INITIAL FIRE SAFETY INSPECTION REPORT

Brandix Apparel Bangladesh Ltd

RSC ID: 24452

Table-1: Findings & Recommendations for 3 storied industrial building

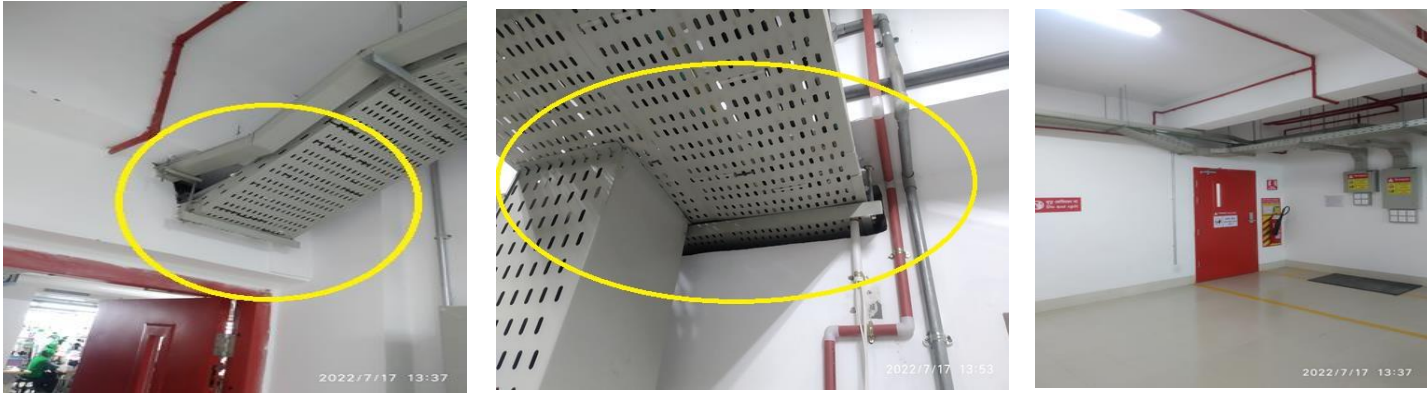
F-2	Fire Rated Construction	Elevator shafts are directly open into the production floor without proper fire separation as installed fire rated door was not functional. Located: 3 storied industrial building	Ensure minimum 1-hr listed/3rd part certified fire rated lift landing doors for elevator shafts otherwise close the area of the shaft with a 1-hr fire-rated construction barrier. If fire rated doors are required to be held open for functional reasons, provide automatic closing devices tied to the fire alarm system.	Within 3months

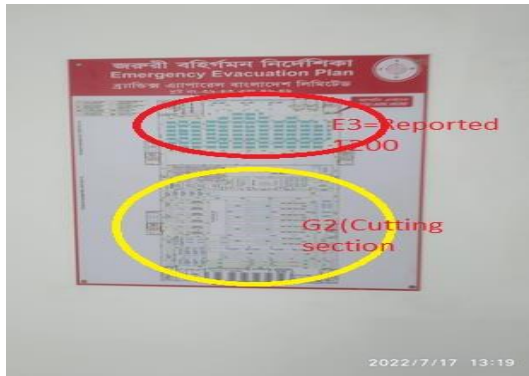
F-6	Fire Rated Construction	The Dining area E3 (Reported capacity 1200) are not properly separated from cutting section (G2) by fire rated construction. Location: 2nd floor of Industrial building	The dining area (E3) is not permitted with moderate hazard occupancies (G2) following part 3, table 3.2.1 of BNBC-2006. Relocate the dining to or from this building to meet the requirement as per BNBC 2006, part 4 chapter 3 section 3.21.3 and part 3 of table 3.2.1.	Within 3 months

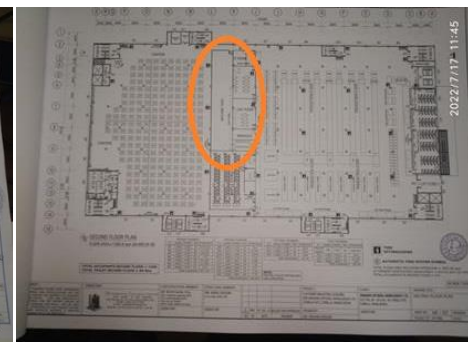
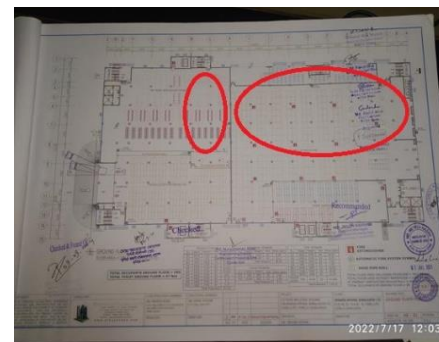
F-7	Means of Egress	Common path of egress travel was more than 23 m in the ground floor & 2nd floor of 3 storied industrial building	Reconfigure the egress arrangement to reduce the maximum common path of travel to not more than 23m.	Within 3 months
-----	-----------------	--	--	-----------------
